**From:** Guzman, Richard  
**Sent:** Monday, July 20, 2015 6:46 PM  
**To:** wanda.d.craft@dom.com  
**Subject:** NRC Staff Request for Additional Information - Proposed TS Changes for MPS2 Spent Fuel Storage (TAC No. MF0435)

DOMINION NUCLEAR CONNECTICUT INC.  
MILLSTONE POWER STATION, UNIT 2  
REQUEST FOR ADDITIONAL INFORMATION IN SUPPORT OF  
PROPOSED TECHNICAL SPECIFICATION CHANGES FOR SPENT FUEL STORAGE  
DOCKET NO. 50-336 (TAC NO. MF0435)

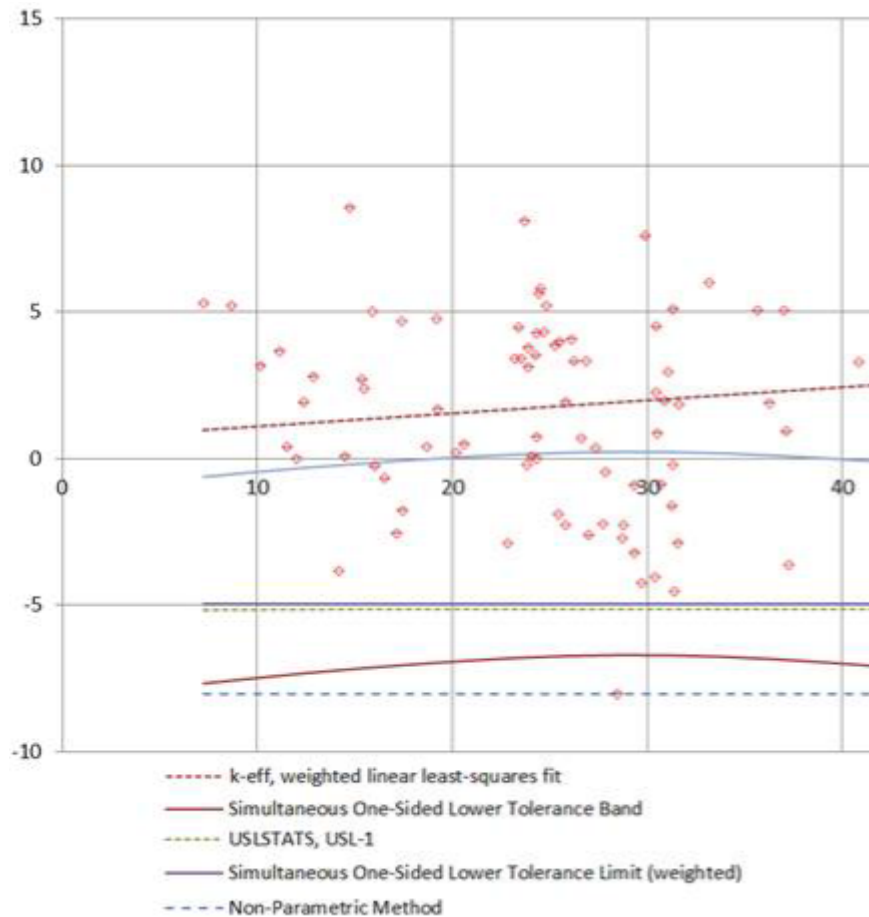
d. The 4.55% adopted for burnup worth uncertainty does not appear to have 95/95 statistical basis. Figure 3.1-2 plots the values calculated by the licensee for the burnup worth uncertainty.

First, it is not appropriate to extrapolate outside the data points (i.e. below 7.4 GWd/MTU and above 60.7 GWd/MTU). Further, statistical analysis of the data should be used to set the 95/95 uncertainty. For data with a trend, the 95/95 uncertainty should increase near the edges of the data and within the range when the data is sparser. The figure below demonstrates a more statistically defensible uncertainty analysis.

Use of the simultaneous one-sided lower tolerance limit is not appropriate because it assumes that there is no burnup dependent trend. Use of the more appropriate simultaneous one-sided lower tolerance band yields uncertainty values significantly larger than both the commonly used Kopp letter 5% of the decrement value and the 4.55% value proposed by DOMINION. The nonparametric method does not rely on the normality of distribution. The linear least squares fit, tolerance limit, tolerance band and non-parametric analyses were performed using techniques adapted from NUREG/CR-6698. Note that the student's t score for the slope of the fit indicates that there is a 92 % probability that the slope is non-zero and the F test based on the correlation coefficient indicates that there is an 84% probability that the fit is better than random.

Considering items a. through e., the licensee should review and revise the fuel depletion analysis bias and uncertainty and the burned fuel criticality analysis presented in Ref. 2.
